BUSH FIRE ASSESSMENT REPORT

Lot 69, 70 and 71 DP 230448

5-7 McDermott Avenue & 1 Phillip Street, Goonellabah

Reference: 23/159

Concept Landscape Plan

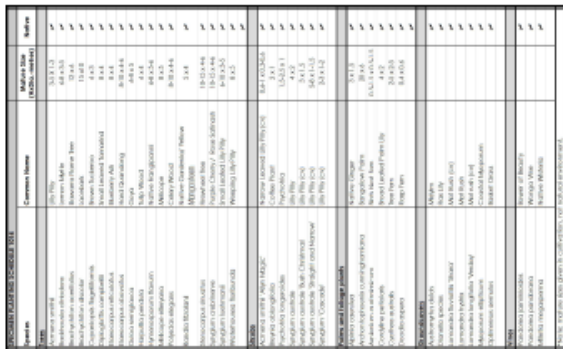
Concept landscape plans DWG No. 1014-LCP01 and 02 Rev B dated 29.01.24 prepared by Alderson and Associates Landscape Architects was received for review and comment relating to compliance with the landscape recommendation.

An assessment of the concept plans shown in Appendix B of this report has been undertaken. It is noted the assessment is limited given the insufficient detail of a concept plan with further assessment required when fully detailed plans are provided to the consent authority for approval.

The assessment established that the concept plan has the potential to be amended to achieve compliance. The following is a summary of amendments required for the final detailed landscape plans to be submitted and approved by the consent authority.

- The non-combustible path around the perimeter of the building is to be increased from 600mm to a minimum 1000mm.
- Remove reference to organic mulch in the raised planter section on Level 2 Plan.

- Provide a specific detail of shrub and ground cover plantings demonstrating plantings are located twice the mature height away from windows and doors, including plantings located below windows on storeys above. For example, the shrubs adjacent to the west elevation and identified in the table on plan have a mature height of 5-8m and are located in close proximity to openings which does not meet IPA requirements.

- The percentage of canopy cover and shrub layer is to be calculated using the percentage of landscaped area rather than the total site area. The central court has been shown with 100% planting coverage. The level 2 private court yards have been shown with greater than 75% planting coverage. In this regard, a performance solution (see appendix C) has been provided for the tree canopy however it relies

upon shrub and groundcover compliance with Appendix 4 PBP2019 in relation to planting location and coverage. Plans to be amended to demonstrate compliance.

- Indicate the location of the proposed vines. It is noted that use of vines is generally not supported in IPA areas, particularly on building structures.

The assessment is limited due to the conceptional nature of the plan and therefore further assessment will need to be undertaken when a detailed landscape plan has been prepared. The performance solution for the increase canopy coverage is provided in Appendix C of this report.
